VIRGINIA ELECTRIC AND POWER COMPANY  
RICHMOND, VIRGINIA 23261

**VIRGINIA ELECTRIC AND POWER COMPANY**  
**NORTH ANNA POWER STATION UNITS 1 AND 2**  
**INSERVICE INSPECTION PROGRAM RELIEF REQUESTS**

NORTH ANNA UNIT 1  
RELIEF REQUEST NDE-19

**NORTH ANNA UNIT 2**  
**RELIEF REQUEST NDE-19**

Sketch #1

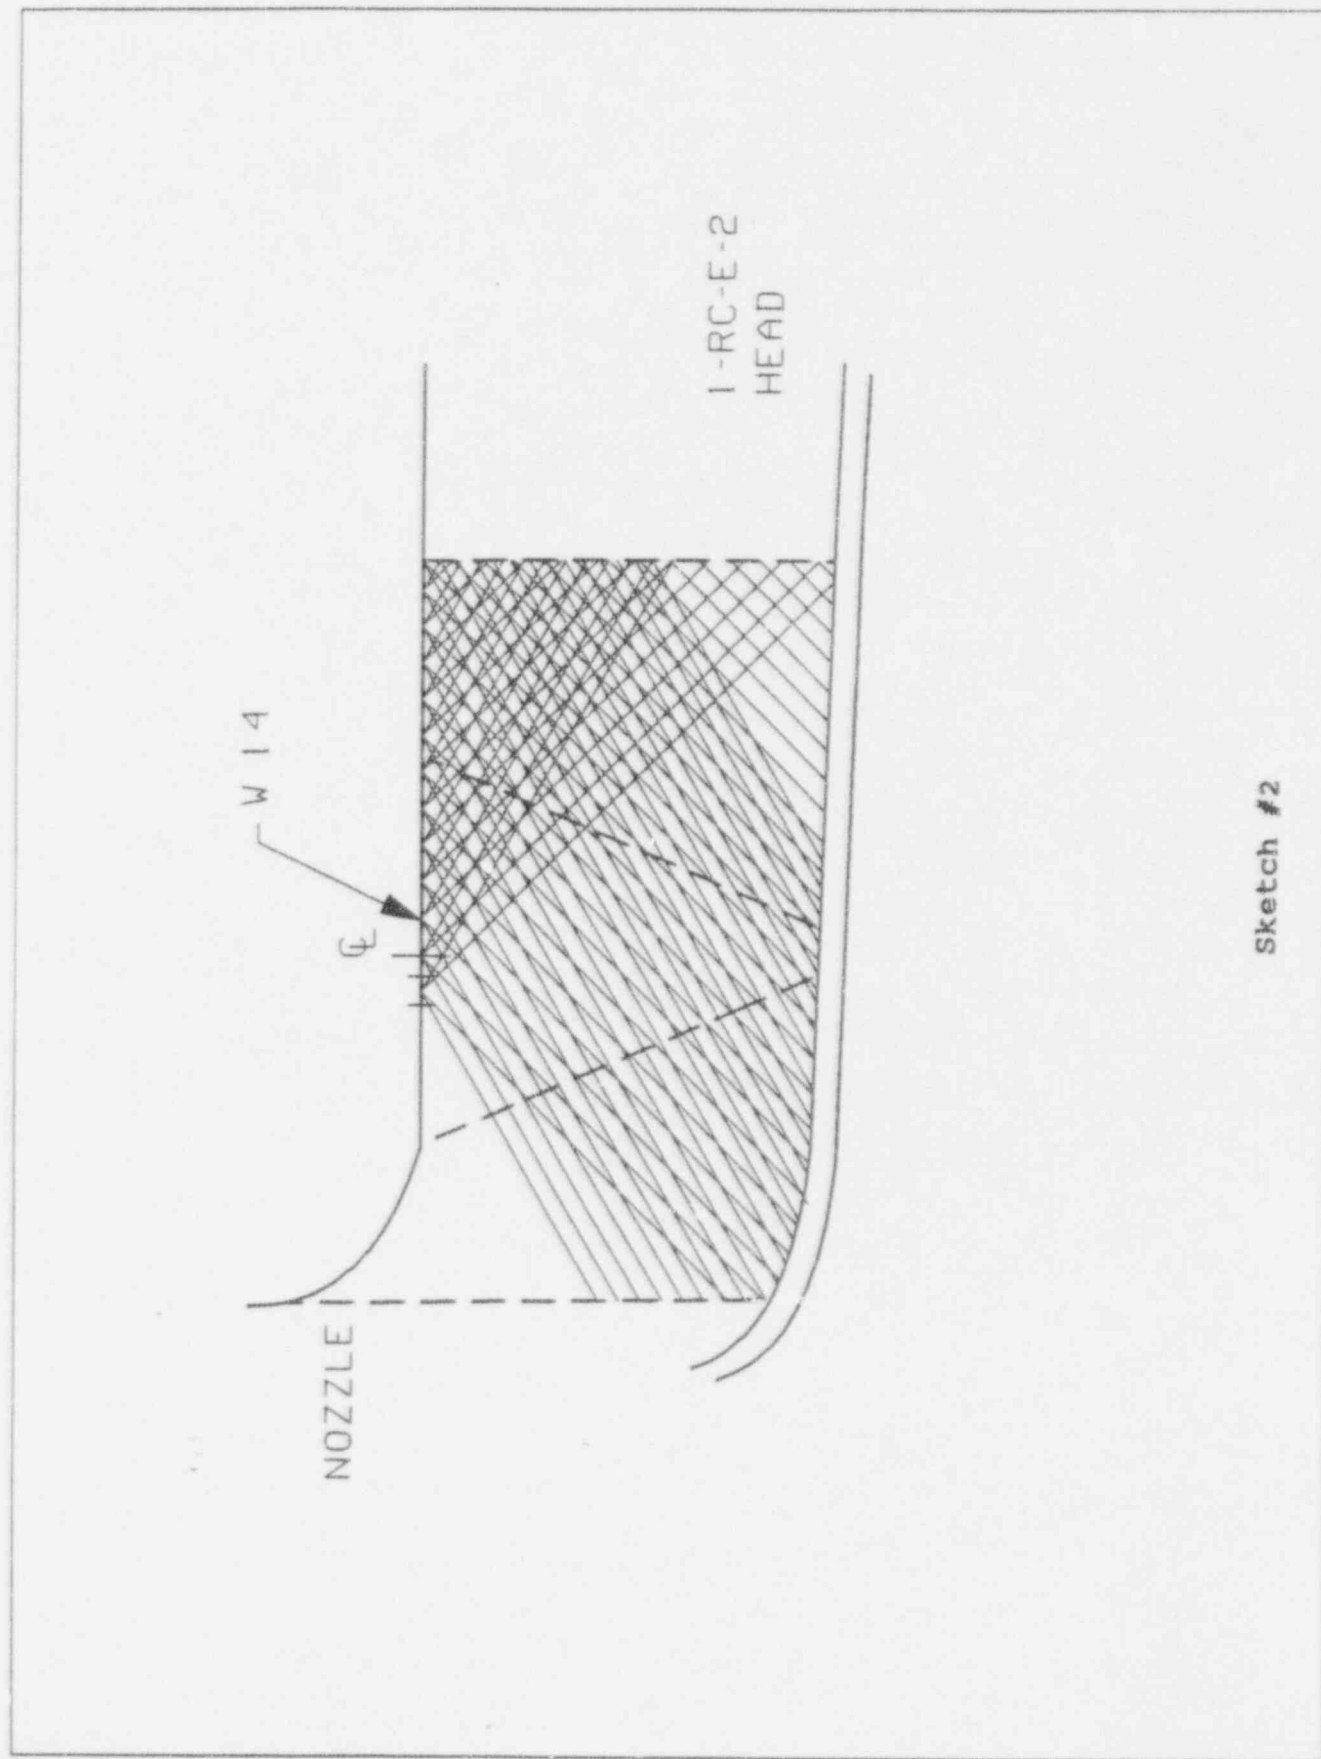
<u>Mark/Weld #</u>	<u>Beam Angle</u>	<u>Exam Area</u>	<u>Scan Direction</u>	<u>% Exam</u>	<u>Reason For Partial</u>	<u>Sketch#</u>
1 (0 to 120 degrees)	0	Weld & Base	-	72	Proximity To Flange And Lifting Lug Interference	1
	45	Weld	2	13		
	45	Weld	5	97		
	45	Weld	7	99		
	45	Weld	8	99		
	60	Weld	2	7		
	60	Weld	5	98		
	60	Weld	7	99		
	60	Weld	8	99		
	45 & 60	Base	2	36		
	45 & 60	Base	5	91		
	45 & 60	Base	7	68		
	45 & 60	Base	8	68

WELD 1

Sketch #2

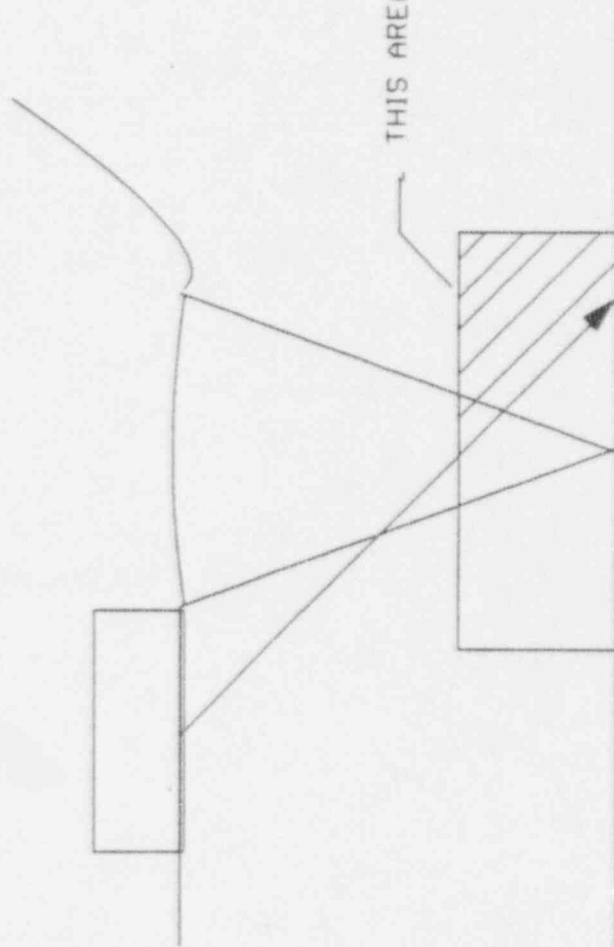
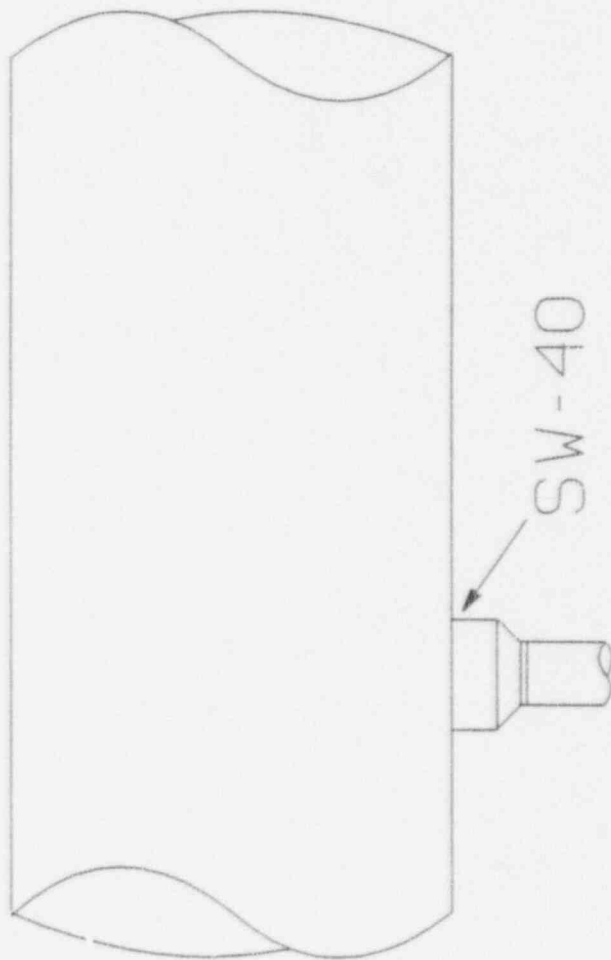
<u>Mark/Weld#</u>	<u>Beam Angle</u>	<u>Exam Area</u>	<u>Scan Direction</u>	<u>% Exam</u>	<u>Reason For Partial</u>	<u>Sketch#</u>
14	0	Weld & Base	-	85	Nozzle Geometry, Cladding Prevents Extended V-path	2
	45	Weld	2	90		
	45	Weld	5	30		
	45	Weld	7	100		
	45	Weld	8	100		
	60	Weld	2	95		
	60	Weld	5	20		
	60	Weld	7	100		
	60	Weld	8	100		
	45 & 60	Base	2	85		
	45 & 60	Base	5	40		
	45 & 60	Base	7	70		
	45 & 60	Base	8	70

THIS AREA NOT EXAMINED

Sketch #4

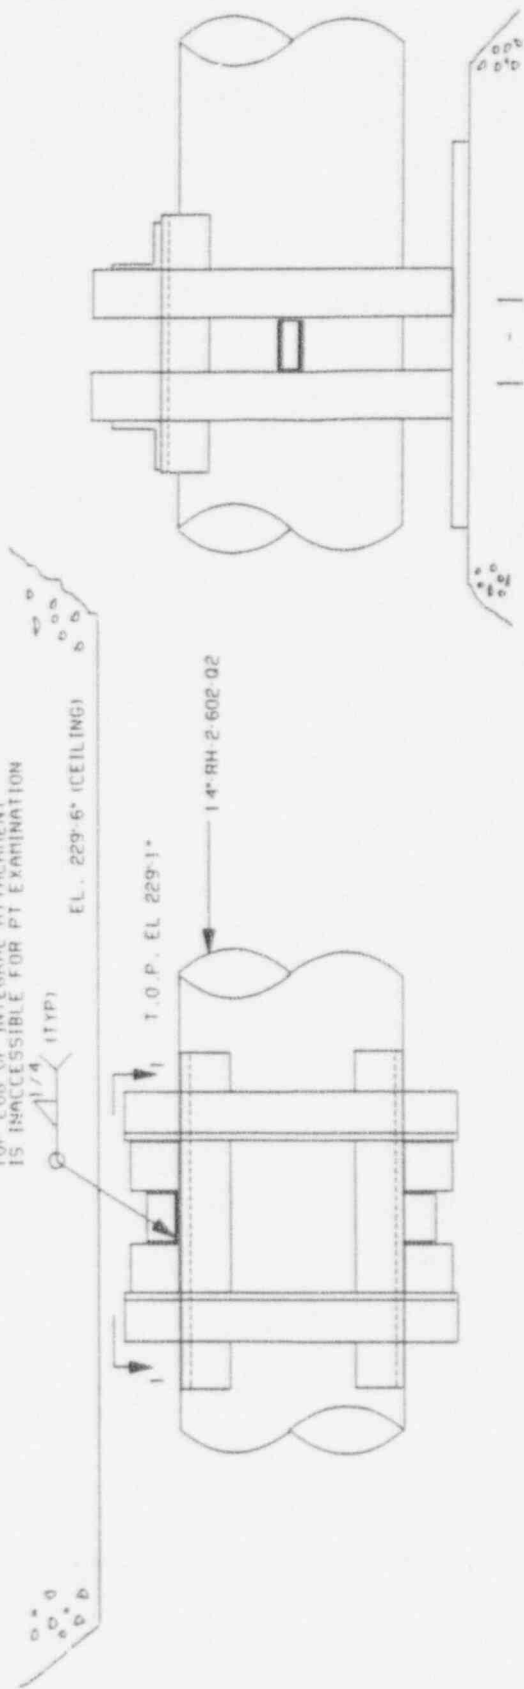
SW-40

TOP LUG OF INTEGRAL ATTACHMENT  
IS INACCESSIBLE FOR PT EXAMINATION

Sketch #1

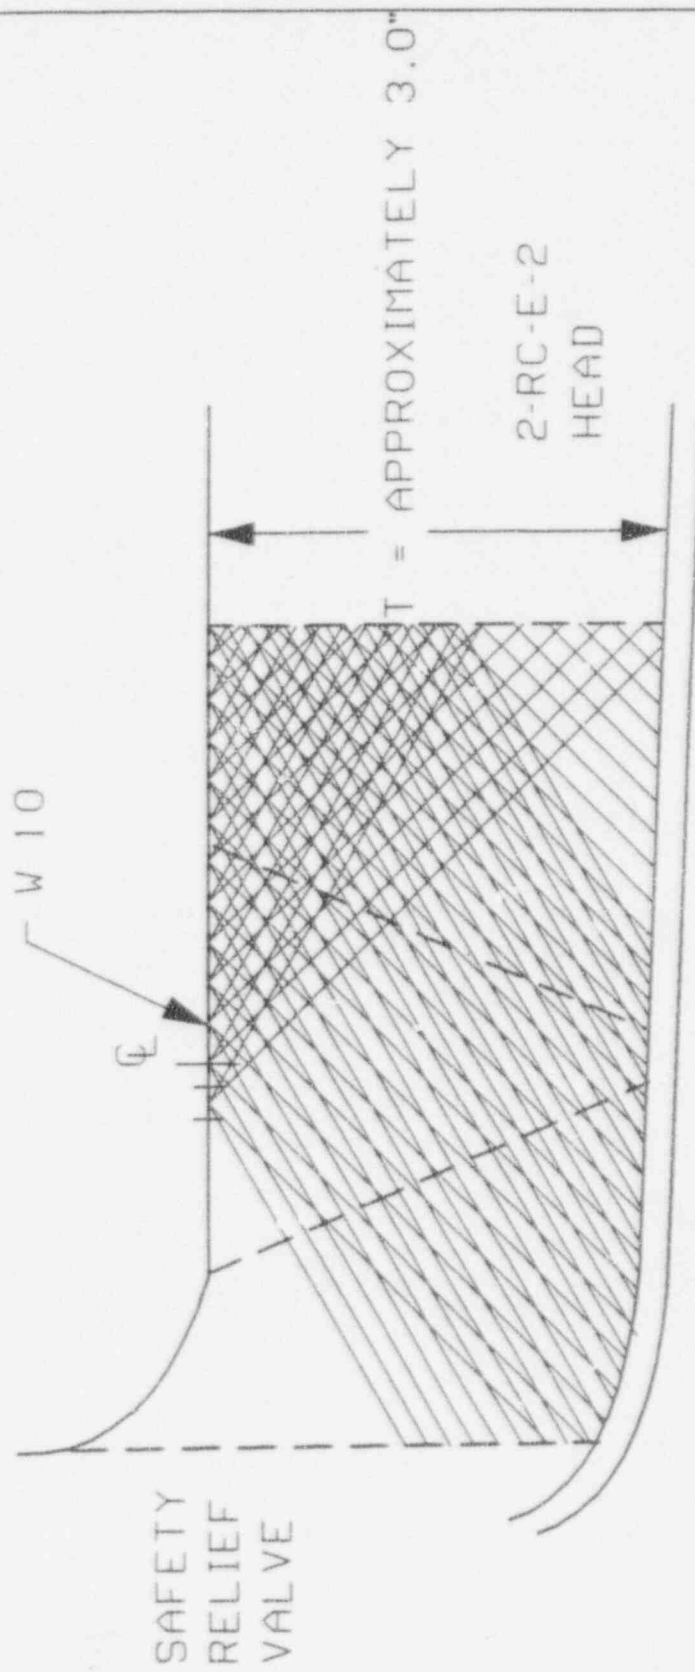
<u>Mark/Weld #</u>	<u>Beam Angle</u>	<u>Exam Area</u>	<u>Scan Direction</u>	<u>% Exam</u>	<u>Reason For Partial</u>	<u>Sketch #</u>
1	0	Weld & Base	-	72	Proximity To Flange And Lifting Lug Interference	1
(0 to 120 degrees)	45	Weld	2	13		
	45	Weld	5	97		
	45	Weld	7	99		
	45	Weld	8	99		
	60	Weld	2	7		
	60	Weld	5	98		
	60	Weld	7	99		
	60	Weld	8	99		
	45 & 60	Base	2	36		
	45 & 60	Base	5	91		
	45 & 60	Base	7	68		
	45 & 60	Base	8	68

WELD 1

Sketch #2

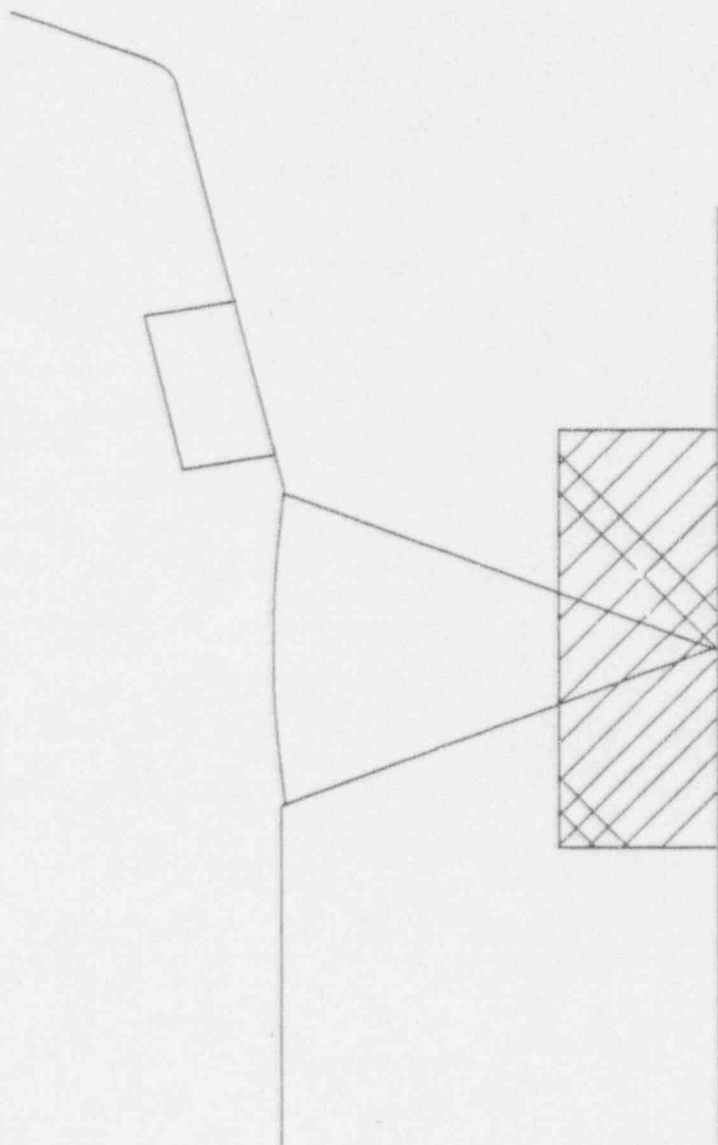
<u>Mark/Weld #</u>	<u>Beam Angle</u>	<u>Exam Area</u>	<u>Scan Direction</u>	<u>% Exam</u>	<u>Reason For Partial</u>	<u>Sketch#</u>
10	0	Weld & Base	-	80	Nozzle Geometry,	2
	45	Weld	2	85	Cladding Prevents	
	45	Weld	5	25	Extended V-path	
	45	Weld	7	100		
	45	Weld	8	100		
	60	Weld	2	90		
	60	Weld	5	15		
	60	Weld	7	100		
	60	Weld	8	100		
	45 & 60	Base	2	80		
	45 & 60	Base	5	35		
	45 & 60	Base	7	65		
	45 & 60	Base	8	65

Sketch #5

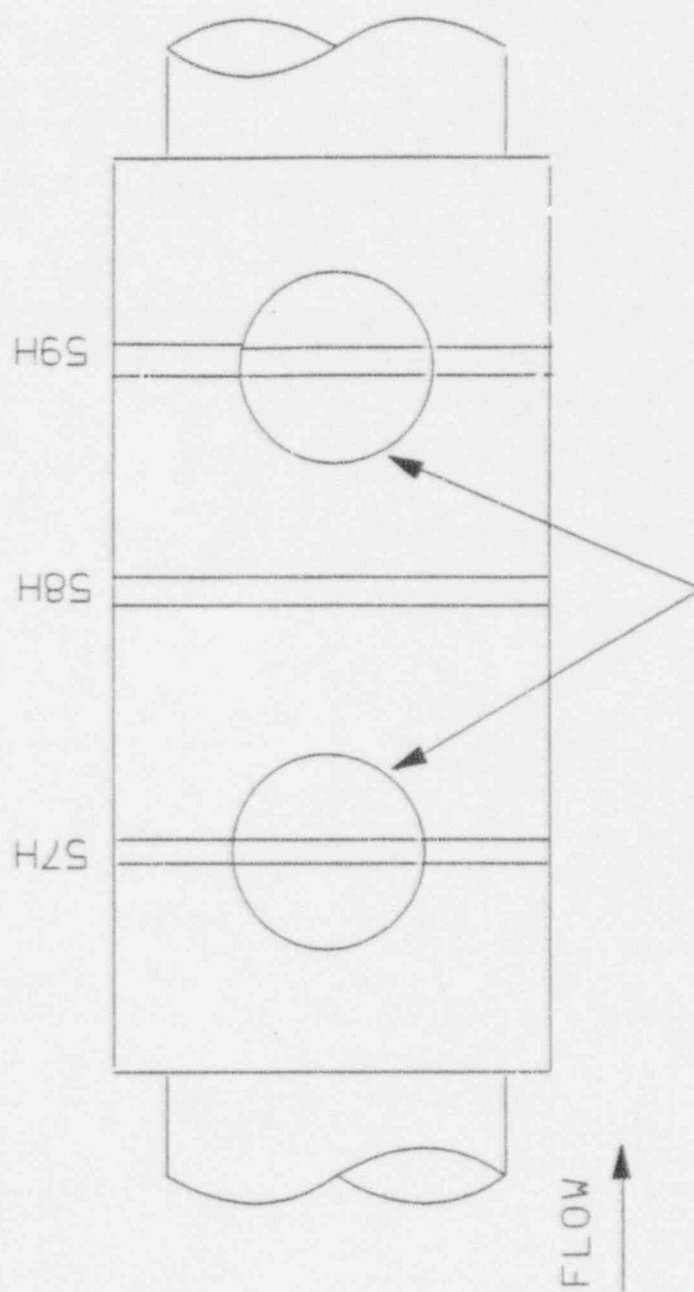
INTEGRAL ATTACHMENTS SW 79, SW-80, SW-88, AND SW-89  
11715-WMKS-101B

LIMITAION: AREAS UNDER WEI.DED  
PIPE CONNECTION FOR SNUBBERS

Sketch #6

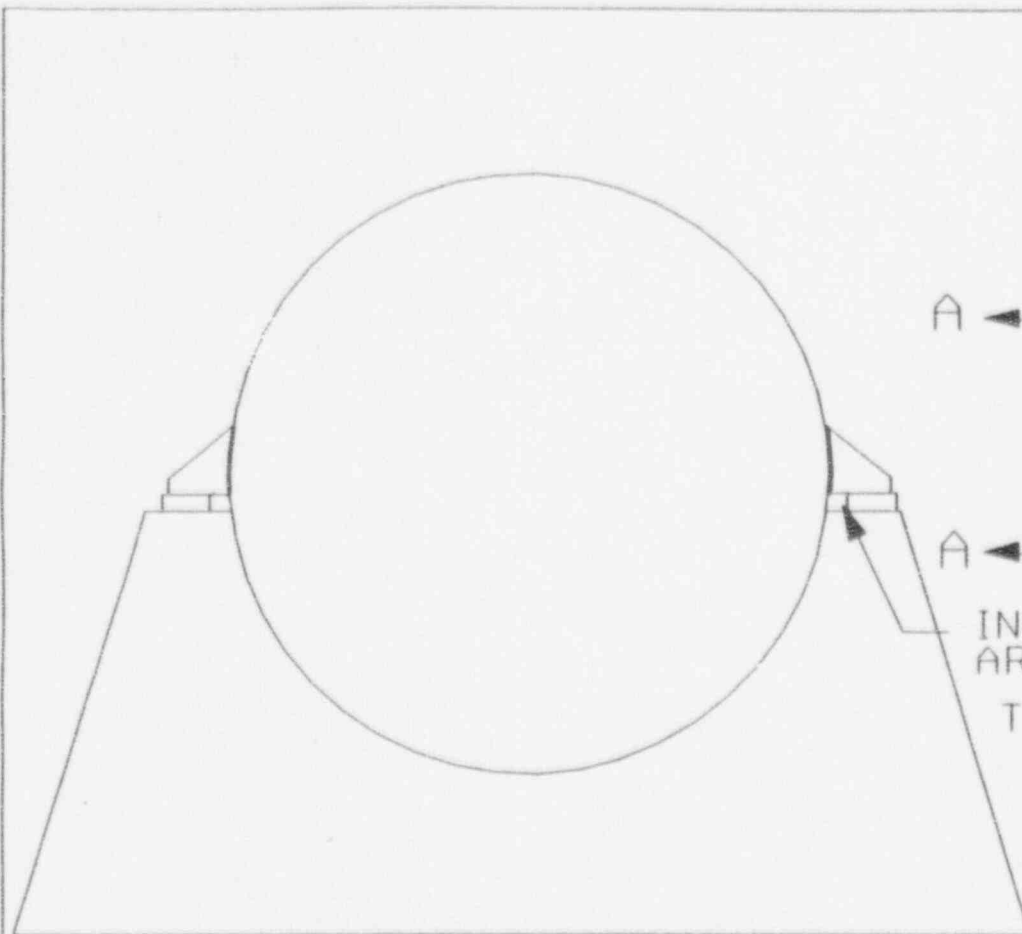
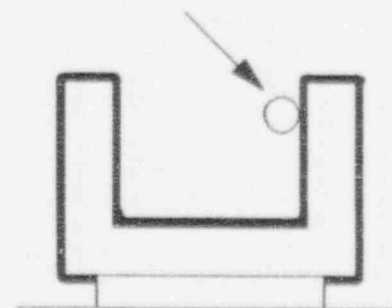
2" DRAIN LINE RESTRICTS WS-02

INACCESSIBLE  
AREA

Sketch #7

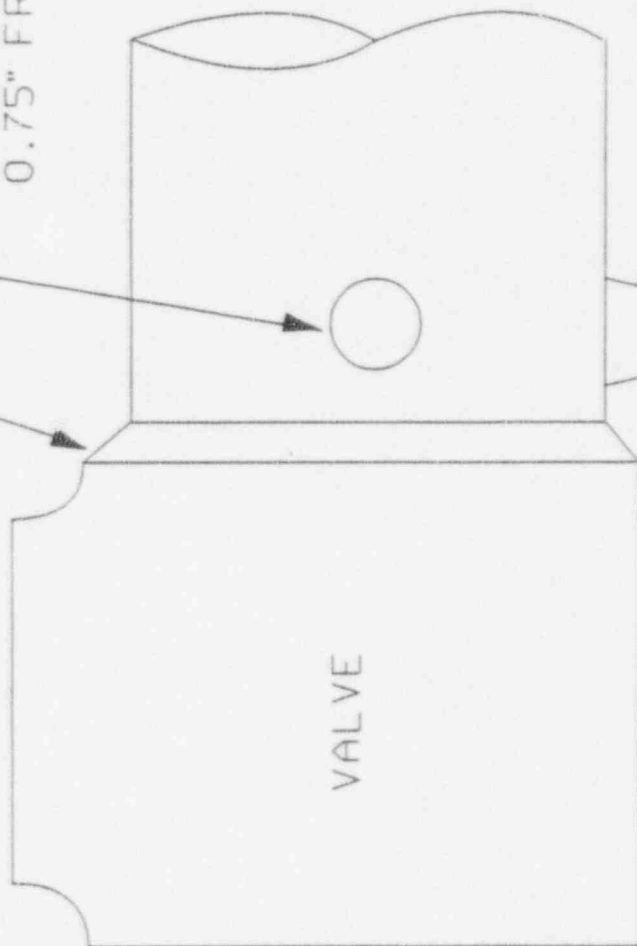
WELD 4A

2.25" SOCKET @ 90 DEGREES  
0.75" FROM TOE OF WELD

2.25" SOCKET @ 180 DEGREES  
0.50" FROM TOE OF WELD

Sketch #8

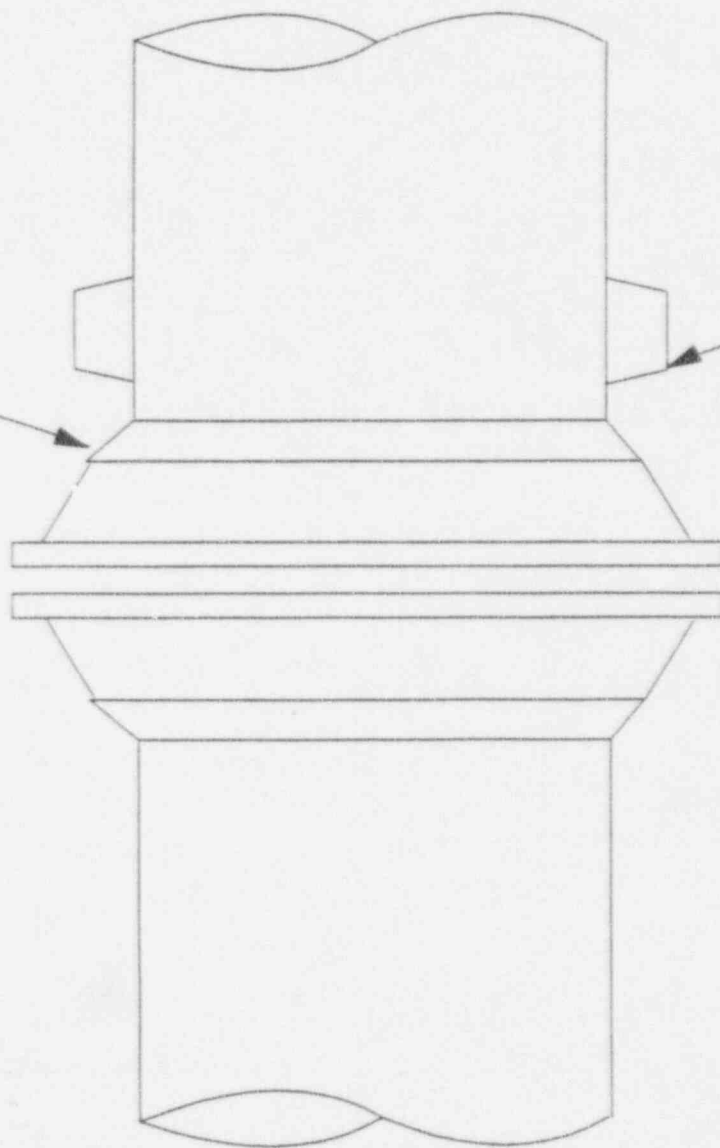
WELD SW-58

2.5" SOCKET WELDED CONNECTIONS  
(TYPICAL OF 2)

Sketch #9

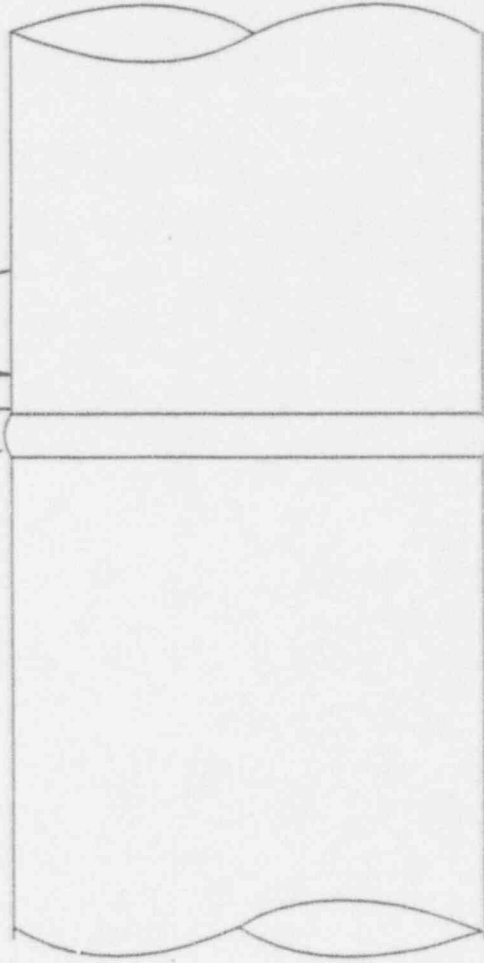
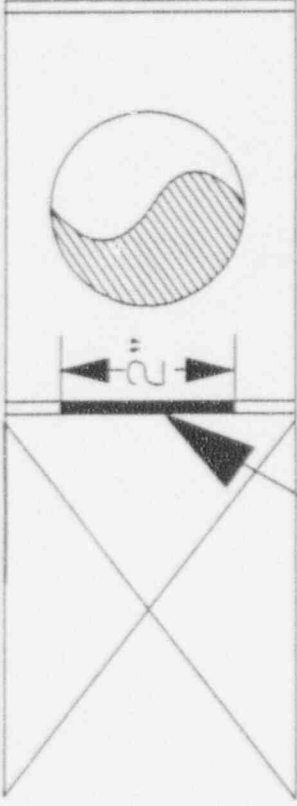
WELD SW-76

2" AREA NOT SCANNED
